USB4 1.0 ENGINEERING CHANGE NOTICE FORM

Actual Change

(a). 11.2.4.1 Parameter Generator

Figure 11-8: PTM ResponseD Tunneled Packet Format Message

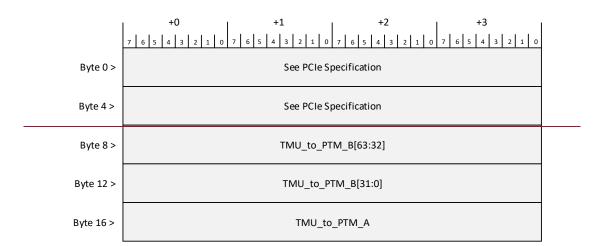
Instead of the *PTM Master Time* and *Propagation Delay* fields defined in the PCIe Specification, a Parameter Generator shall include the most recent TMU_to_PTM Parameters in the PTM ResponseD Message. The format and example of a PTM ResponseD over the PCIe Tunnel is as depicted in Figure 11-8.
